**August 1, 2014**  
**BOARD OF COUNTY COMMISSIONERS**  
**ORANGE COUNTY, FLORIDA**

**ADDENDUM NO. 4**  
**IFB NO. Y14-748**  
**ORANGE COUNTY EASTERN WATER RECLAMATION FACILITY**  
**PHASE V AND CENTRIFUGE DEWATERING IMPROVEMENTS**

4 VALVE BOX SETTING SCALE: NONE

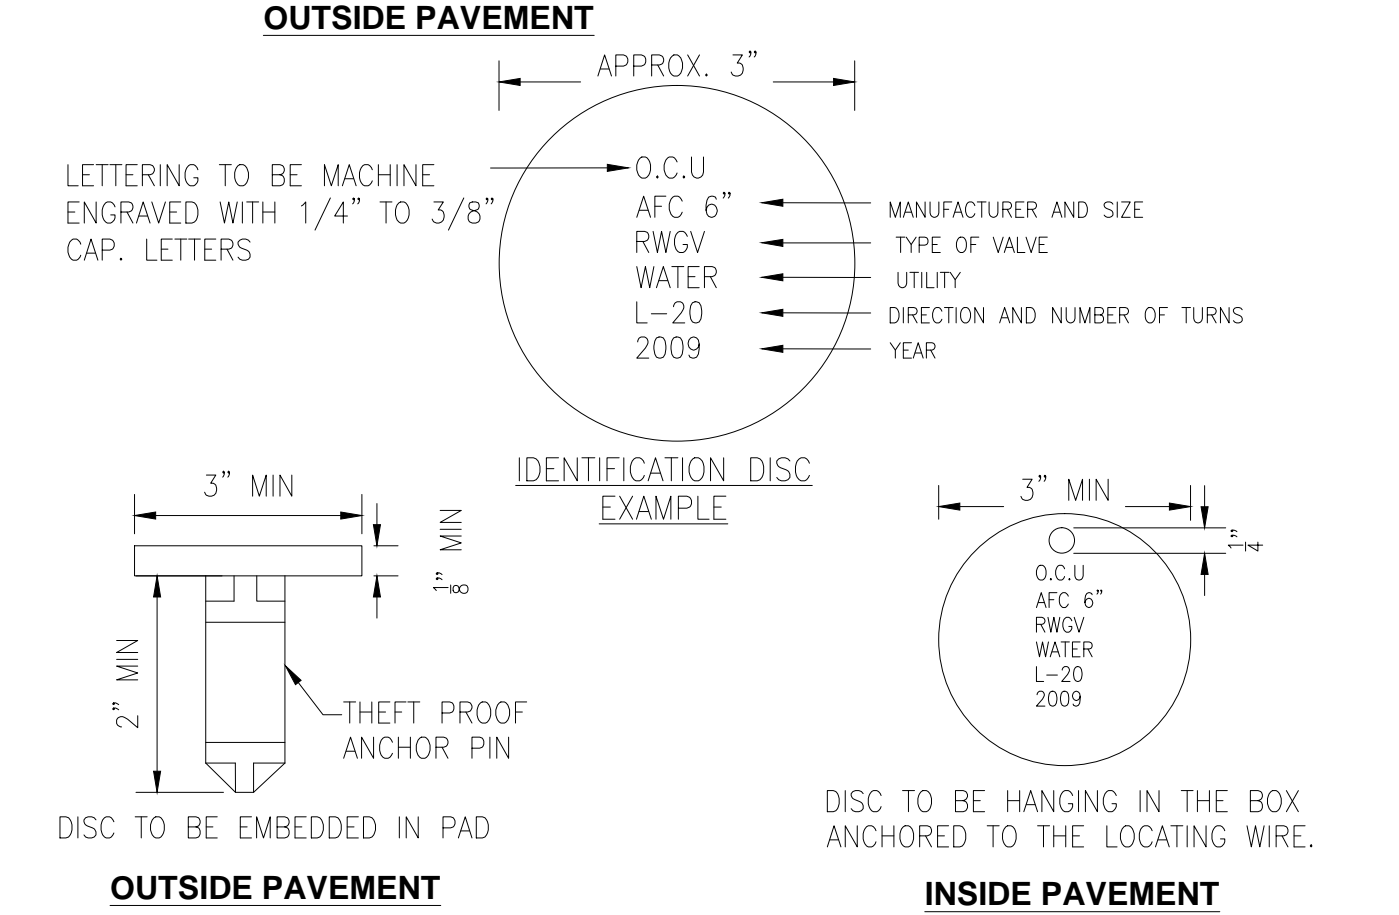
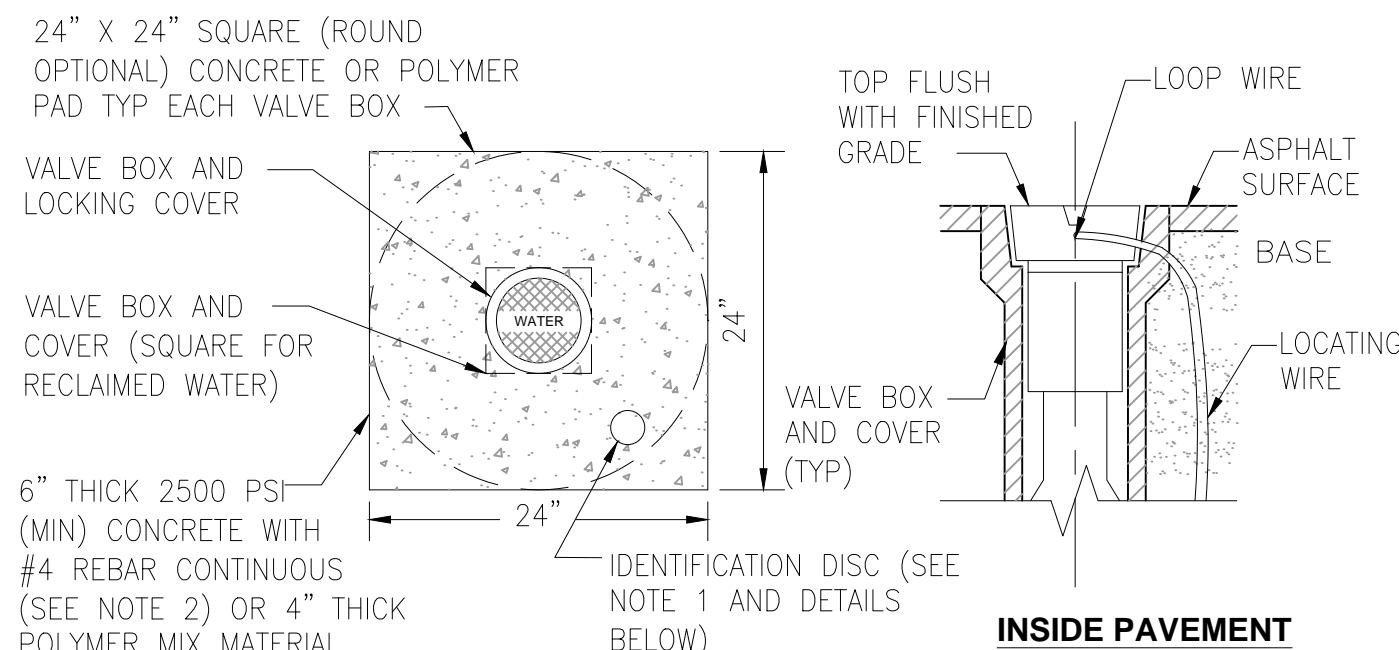
45. With two bid packages, A & B, the valve box detail C-504 in package A does not include a valve position indicator. However, the detail C-504 on bid package B does show the valve box detail with a valve position indicator. So the question is, are valve position indicators required for all buried valves on both bid packages A & B?

*Bid Package B, Detail 4 and Detail 5 on Drawing C-504 are revised to be consistent with the details in Bid Package A (**Attachment**).*

**PLATFORM PLAN**  
 SCALE: 1/4" = 1'-0"

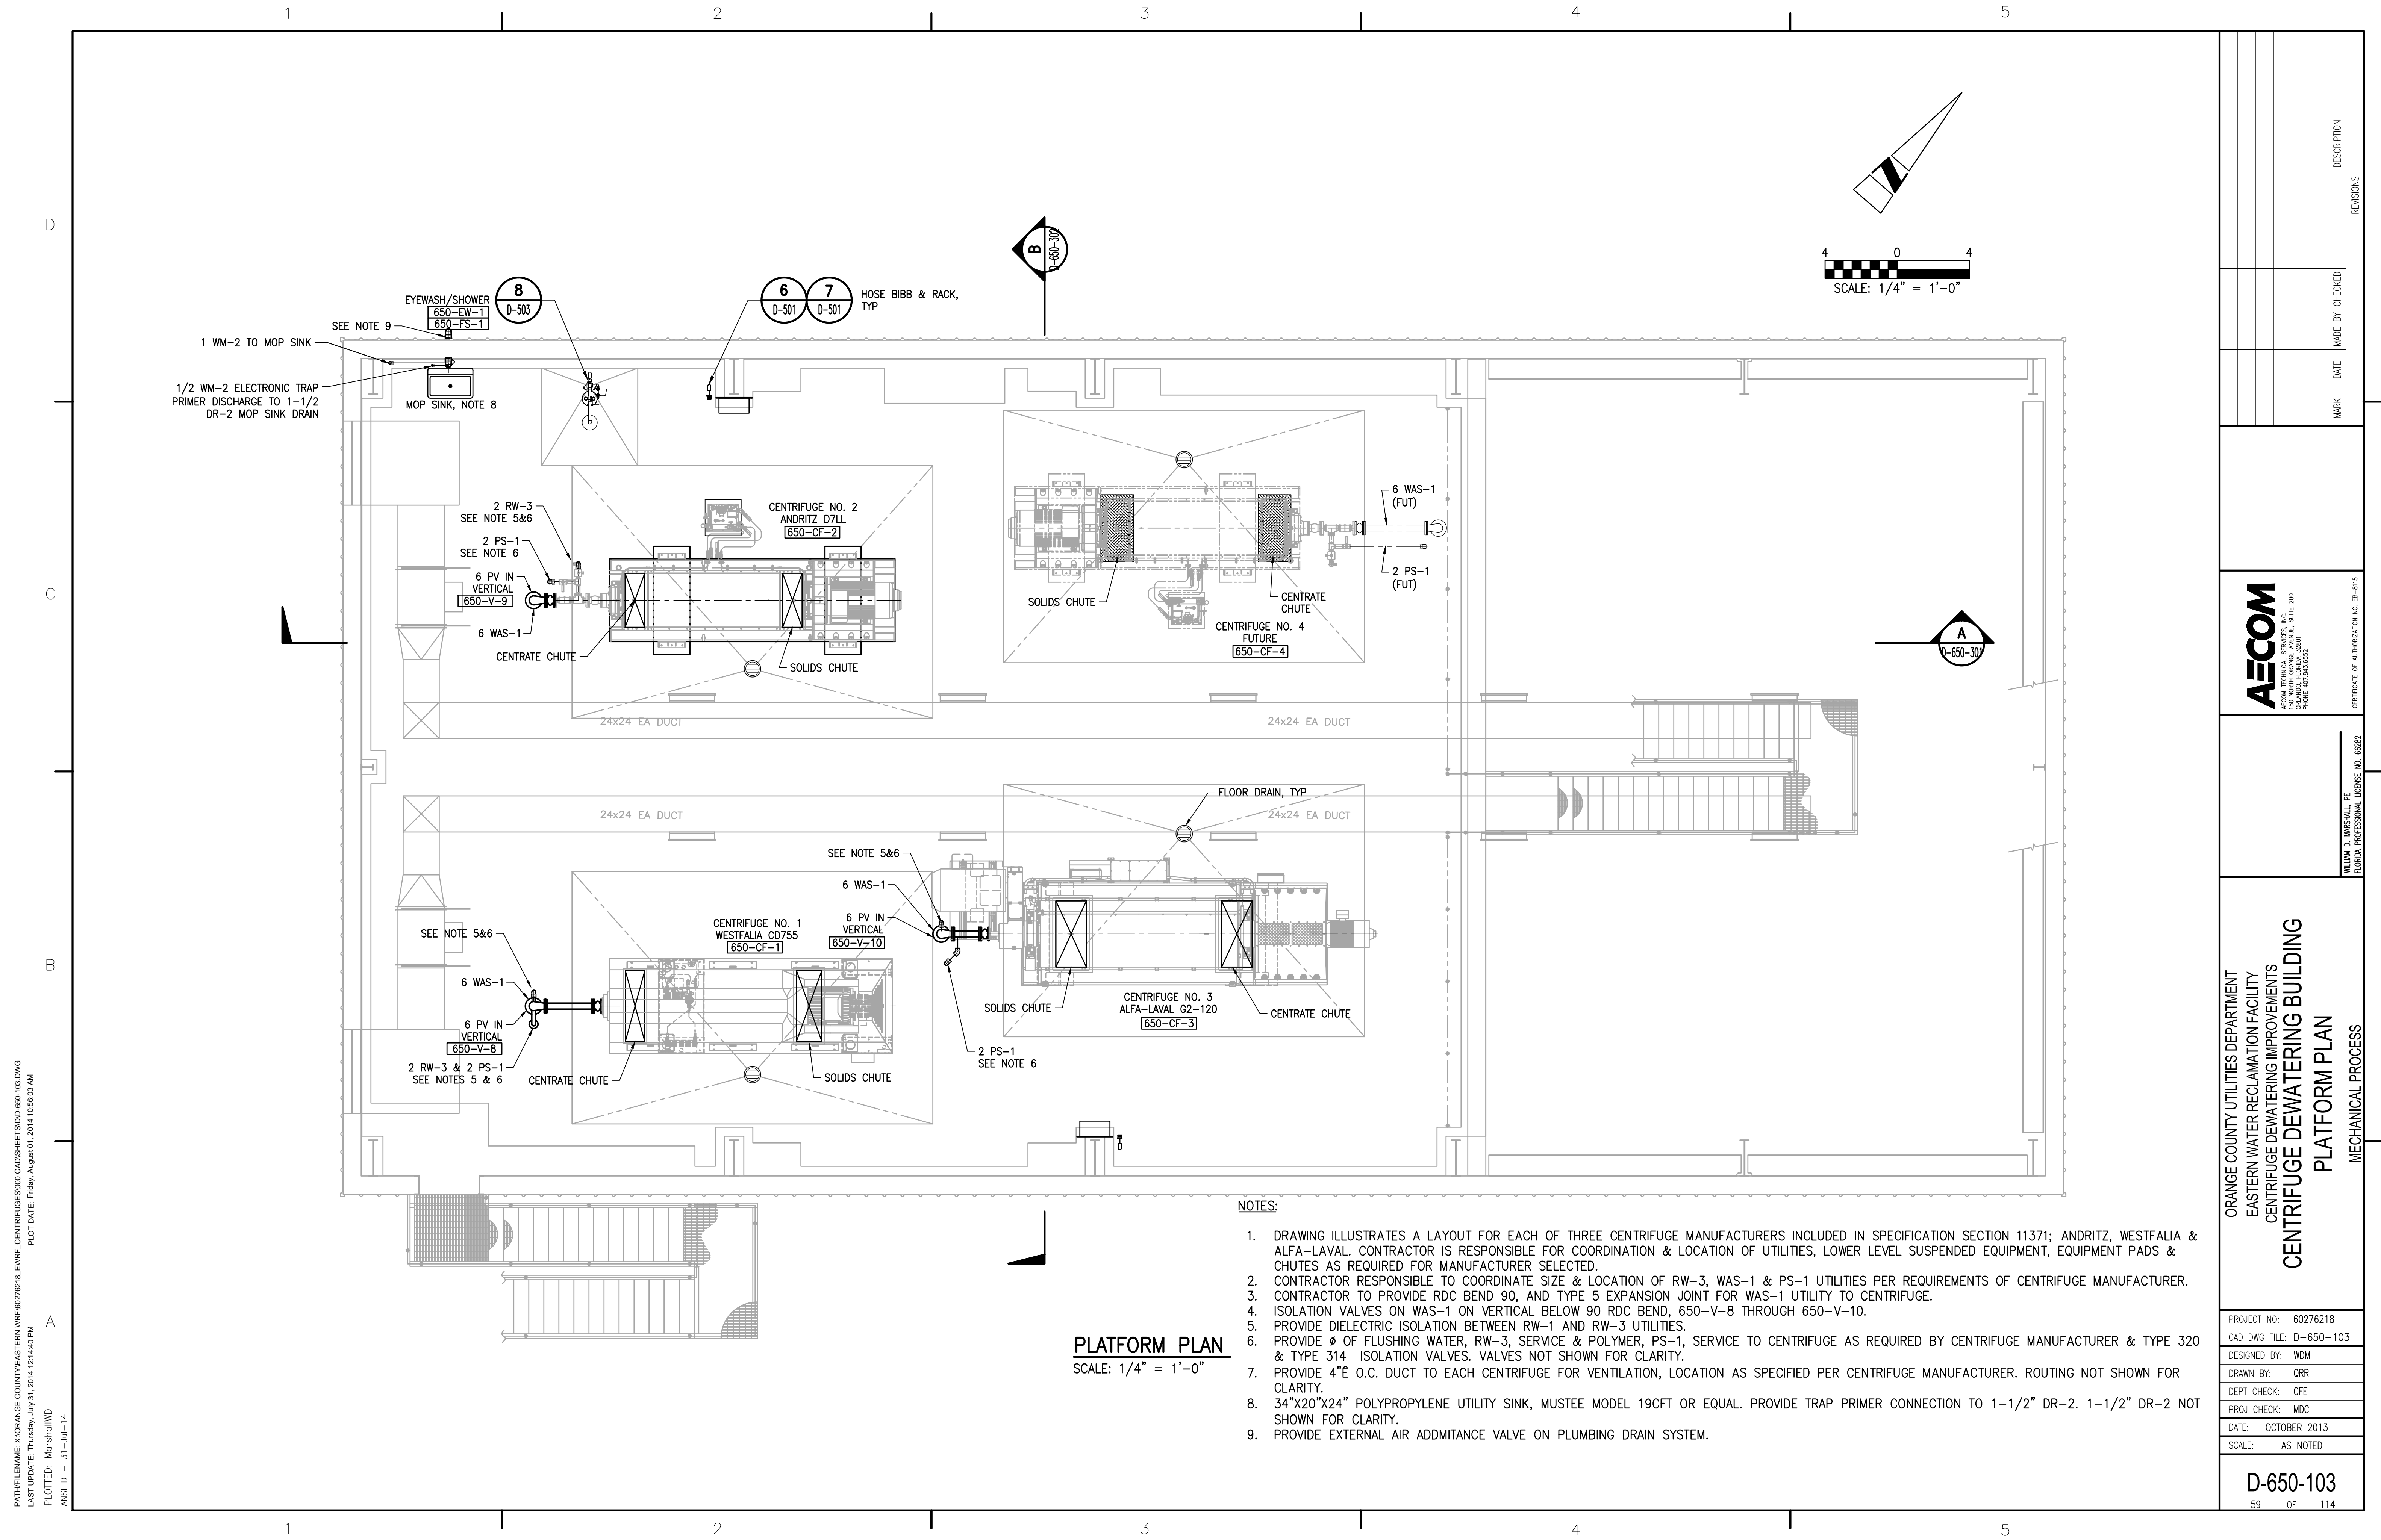
12. Refer to Bid Package B. Drawing D-650-102 line 6 RW-1 has two (2) TEEs drawn in a vertical orientation. There is not a section view showing the continuation of these TEEs. Can you please advise on the intent of these two fittings where the 6" line continues or is it a blind flange and transition to the 2 RW-3 line? Attached is a redlined drawing referencing the two fittings.

*The tees are turned up with a blind flange that is tapped to transition to the RW-3 line providing reclaimed water to the Centrifuges. Please reference Drawing D-650-103, Notes 5 & 6. Each Centrifuge manufacture has a customized orientation regarding polymer, WAS and reclaimed water services. Each of the three manufacturers specified is illustrated on Drawing D-650-103, with the general arrangement of these utilities illustrated on the Drawings. The Contractor is responsible to provide the utilities in the specific orientation and size as required by the selected Centrifuge manufacturer and coordinate those respective locations within the area below the equipment platform. Drawings D-650-102 and D-650-103 are revised to provide additional clarity (**Attachment**).*
